Technical Service Information

THM 4L60-E/4L65-E NEW OIL PUMP TO CASE SEAL FOR 2004 MODELS

Figure 1

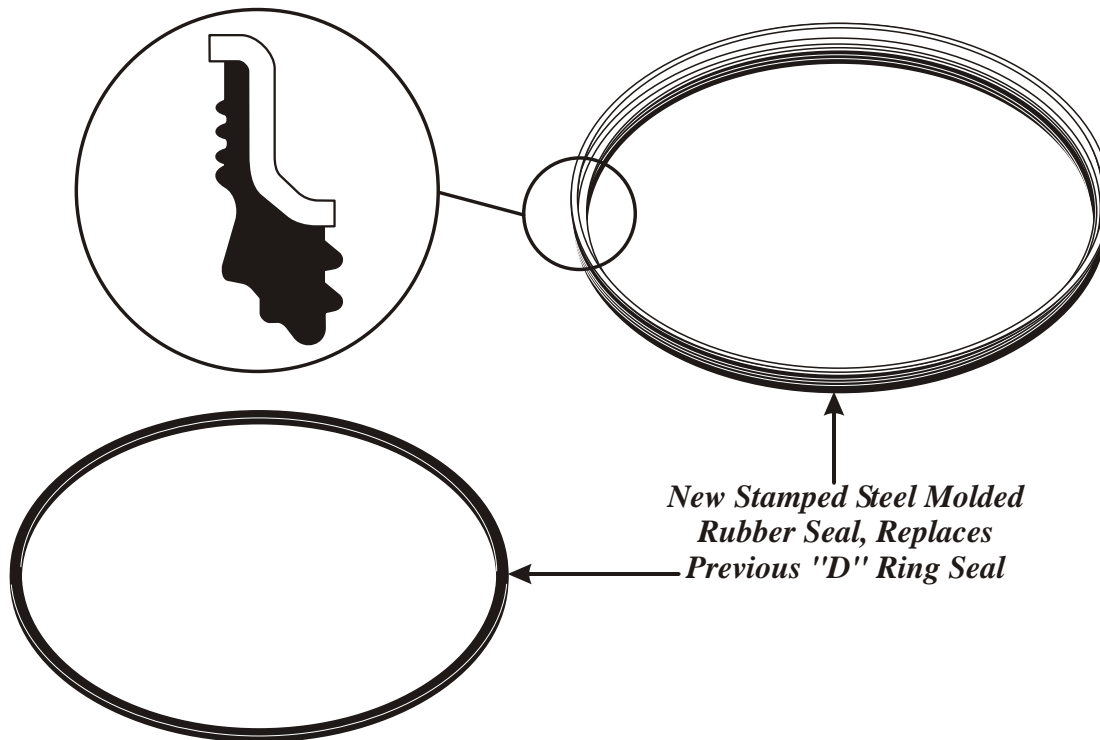
CHANGE: An improved oil pump to case seal design has been implemented on the 4L60-E/4L65-E family of transmissions, to replace the previous design "D" ring seal, as shown in Figure 1. The complete design was implemented in three phases, beginning in September, 2002 and completion in March 2004.

We have provided you with a chart in Figure 1, to help eliminate mis-assemblies

Component	Case Prior To July 2002	Phase 1 Case Modified Chamfer After Jan. 2003	Phase 2 Case Modified Casting After Nov. 2003	Phase 3 Case And New Seal After March, 2004
Pump Body 24230111 <i>Without "D" ring seal groove</i>	DO NOT USE	DO NOT USE	DO NOT USE	"MUST" USE
Pump Body 24230110 <i>Relocated "D" ring seal groove</i>	MAY USE	USE	USE	DO NOT USE
"D" Ring Seal 24210605	USE	USE	USE	DO NOT USE
New Stamped Steel Molded Rubber Seal 24226315	DO NOT USE	DO NOT USE	DO NOT USE	"MUST" USE
Previous Pan Bolt 8657000 M8 X 1.25 X 18.9 <i>(Before Jan, 04)</i>	USE	USE	DO NOT USE	DO NOT USE
New Pan Bolt 24226008 M8 X 1.25 X 17.9 <i>(After Jan, 04)</i>	MAY USE	MAY USE	MAY USE	"MUST" USE

OIL PUMP BODY CHANGES

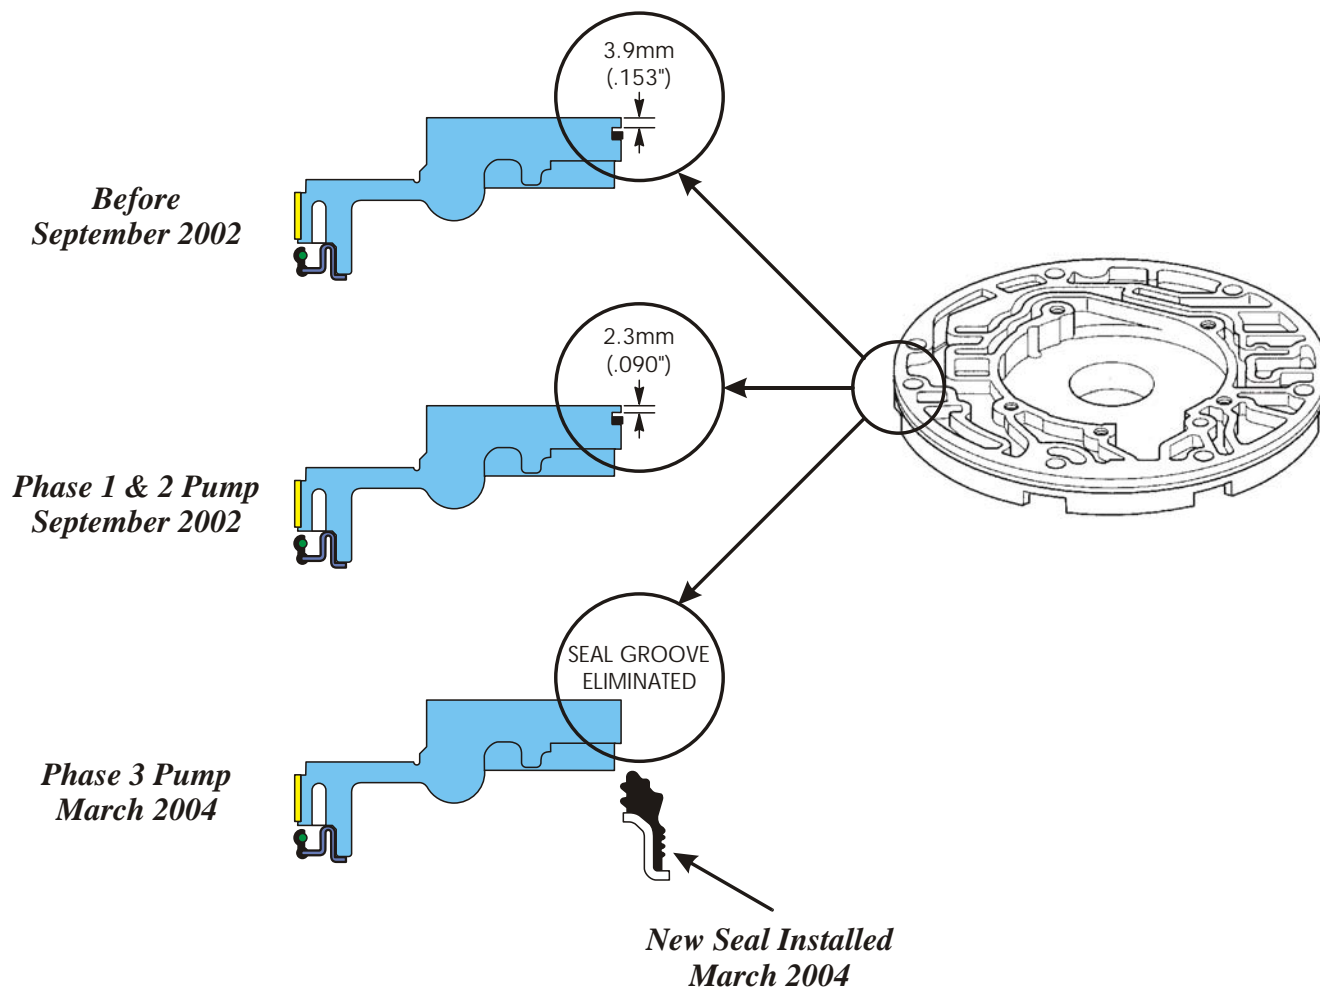
- (1) **OIL PUMP BODY** - Beginning in September 2002, the "D" ring seal groove moved 1.6mm (.062") inward on the pump body to place the sealing surface deeper into the case bore. The relocated pump body groove can be identified by measuring the groove location, as shown in Figure 2. Pump bodies that measure 2.3mm (.090"), as shown in Figure 2, are the ones with the relocated seal groove. Pump bodies that measure 3.9.. (.153"), as shown in Figure 2, are the prior to September 2002 design. Phase 3 eliminates the "D" ring seal and seal groove.

Phase 1 Pump Body:

Beginning in September 2002, the "D" ring seal groove moved 1.6mm (.062") inward on the pump body to place the sealing surface deeper into the case bore. The relocated pump body groove can be identified by measuring the groove location, as shown above.

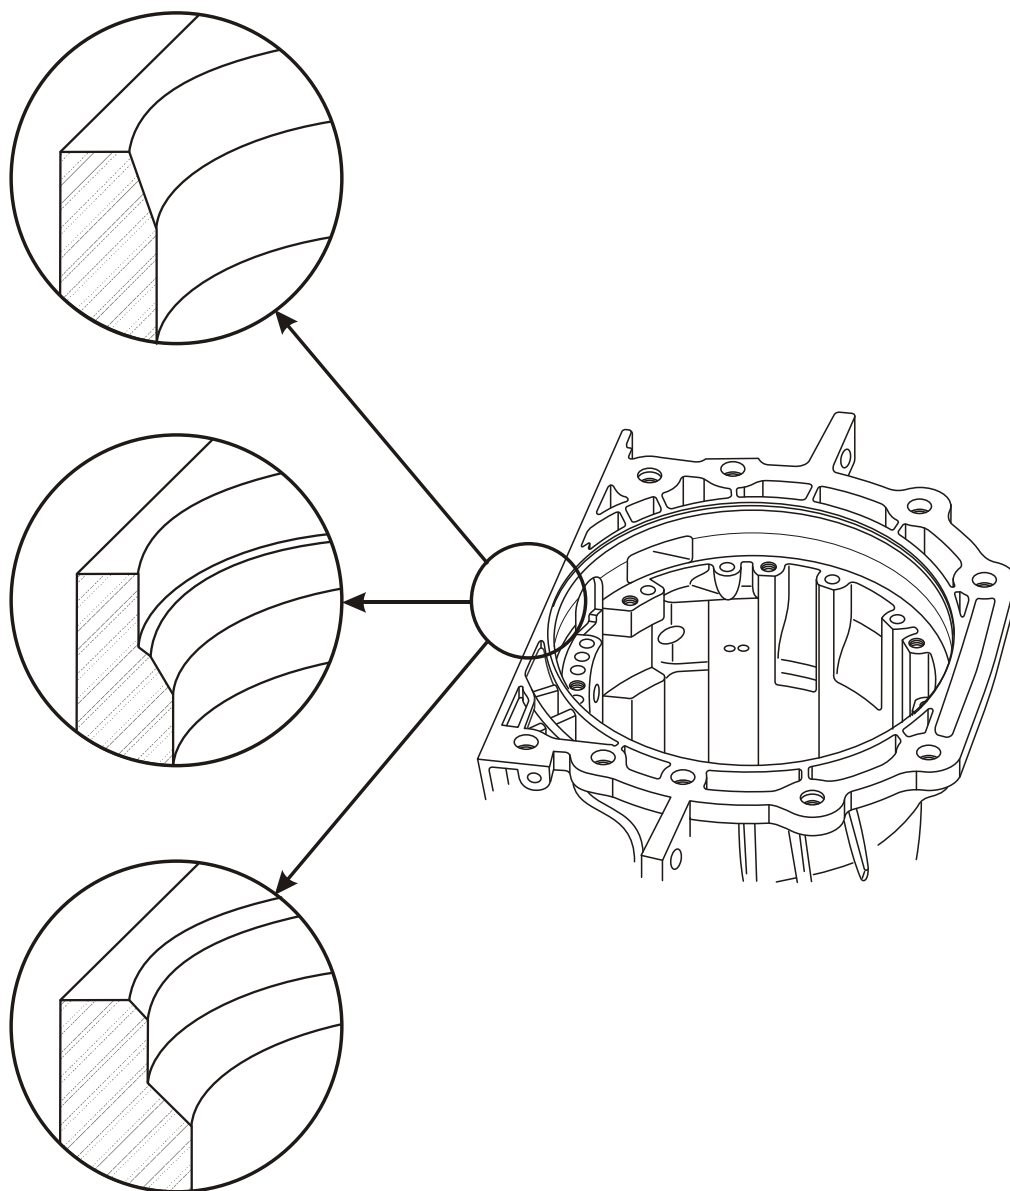
- (2) **TRANSMISSION CASE** - Phase 1 also machined a modified case chamfer leading into the pump case bore, as shown in Figure 3. Phase 2 modified the case casting and again the machined chamfer into the pump bore. The casting change left additional material in the surrounding pump bore to allow deeper bore machining in order to create the necessary sealing surface for the new stamped steel molded rubber design seal, as shown in Figure 3.

Phase 1 Case:

Revised machining with a case chamfer leading into the pump bore. This chamfer is designed to help eliminate possible "D" ring damage during pump installation on the assembly line.

Phase 2 Case:

The case casting and the chamfer into the case bore were both modified. The casting change left additional material in the surrounding pump bore to allow deeper bore machining in order to create the necessary sealing surface for the new pump seal design. The leading surface into the pump bore was also machined with a modified chamfer.

Figure 4

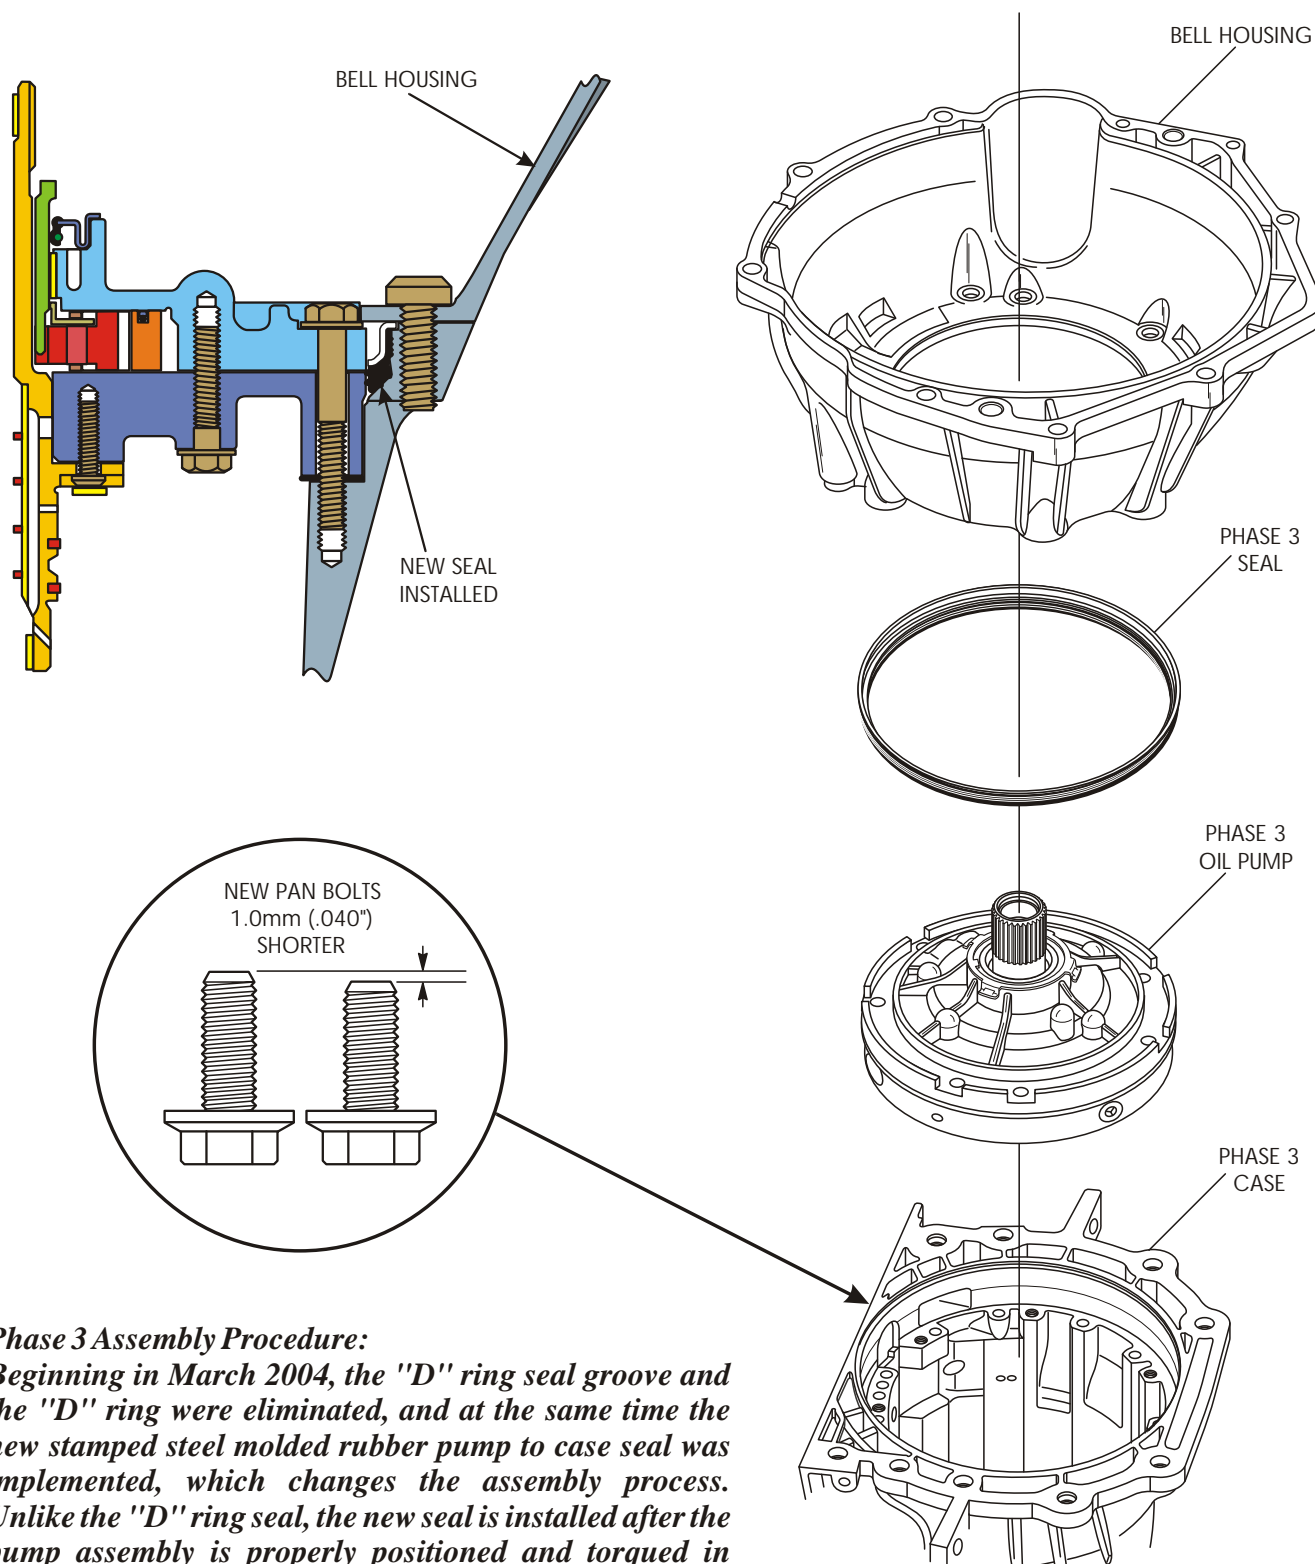
- (3) **OIL PUMP TO CASE SEAL** - Beginning in March 2004, the new stamped steel molded rubber seal is used to seal the pump assembly to the case, as shown in Figure 3 and 4.

- (4) **OIL PAN BOLTS** - Beginning in January, 2004, 1.0 mm (.040") shorter pan bolts were put into production units in preparation for Phase 3. As a result of the modified casting and the deeper pump bore machining, the area between the oil pan mounting surface and the pump bore was decreased. Because of the reduced material in this area, it was necessary to use the shorter pan bolts. Early pan bolts, before November 2002, should not be used with the modified case design, since they are 1.0 mm (.040") longer and could deform the oil seal chamfer surface in the case bore. Refer to Figure 4 for pan bolt differences.

Phase 3 Assembly Procedure:

Beginning in March 2004, the "D" ring seal groove and the "D" ring were eliminated, and at the same time the new stamped steel molded rubber pump to case seal was implemented, which changes the assembly process. Unlike the "D" ring seal, the new seal is installed after the pump assembly is properly positioned and torqued in place. Seating the seal is accomplished when the bell housing is installed, which presses the seal into position between the pump and the case bore, as shown above.
